Model: GW-C2	Date: 19-Dec-07	No.: RB282001a
--------------	-----------------	----------------

Subject: ROM History (BICU)		Prepared by: Y.Yoshida	
From: 1st Tech. Support Sec. Service Support Dept.			
Classification:	<input type="checkbox"/> Troubleshooting	<input type="checkbox"/> Part information	<input type="checkbox"/> Action required
	<input type="checkbox"/> Mechanical	<input type="checkbox"/> Electrical	<input type="checkbox"/> Service manual revision
	<input type="checkbox"/> Paper path	<input type="checkbox"/> Transmit/receive	<input type="checkbox"/> Retrofit information
	<input type="checkbox"/> Product Safety	<input checked="" type="checkbox"/> Other ()

This RTB has been issued to announce the firmware release information for the Model GW-C2 BICU.

Subject: Firmware Release Note: Printer/Scanner		Prepared by: Y.Yoshida	
From: 1st Tech. Support Sec. Service Support Dept.			
Classification:	<input type="checkbox"/> Troubleshooting <input type="checkbox"/> Mechanical <input type="checkbox"/> Paper path <input checked="" type="checkbox"/> Other ()	<input type="checkbox"/> Part information <input type="checkbox"/> Electrical <input type="checkbox"/> Transmit/receive	<input

See the following diagram for the corrected illustration.

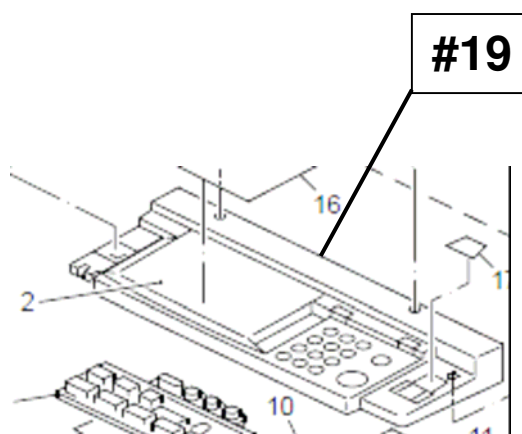
Incorrect part number	Correct part number	Description	Q'ty	Int	Page	Index	Note
	B2431451	CASE:OPERATION SUB-UNIT	0 - 1		11	#19

Change: An index in the illustration was added.

Reason: Correction of illustration and part number.

Part encircled in red in the following diagram is deleted.

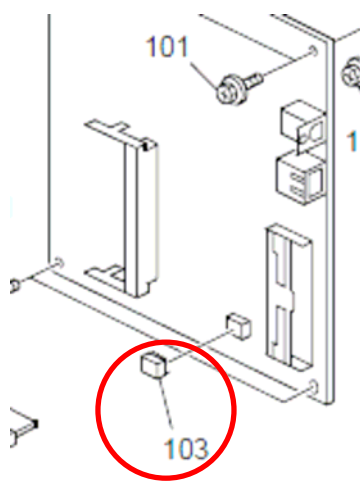
Change: Part number **14076612** and the illustrations were deleted.

Reason: EEP-ROM as a new spare part cannot be used on the GDI controller board as a single replacement component because it causes network connection failure. Please replace the controller board if you need to replace the RAM.

See the following diagram for the corrected illustration.

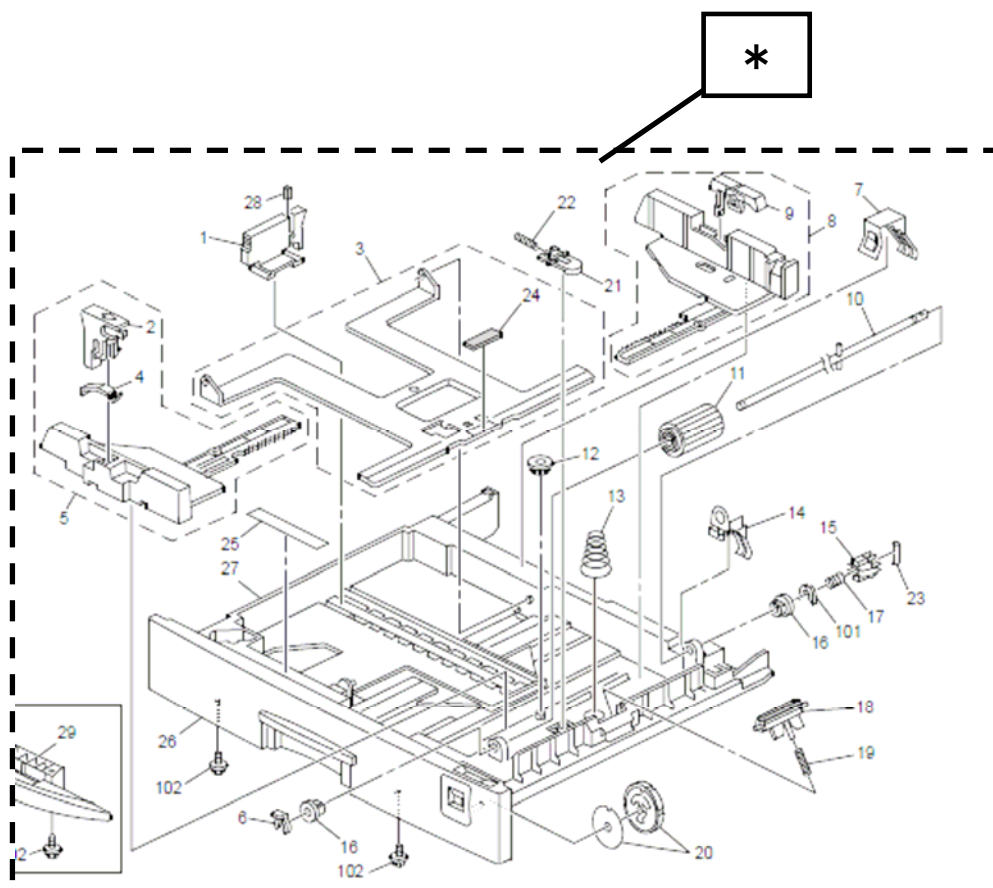
Incorrect part number	Correct part number	Description	Q'ty	Int	Page	Index	Note
	B2452840	PAPER TRAY:PD-C2:ASS'Y	0 - 1		23	*

Change: An index in the illustration was added.

Reason: Correction of illustration and part number.
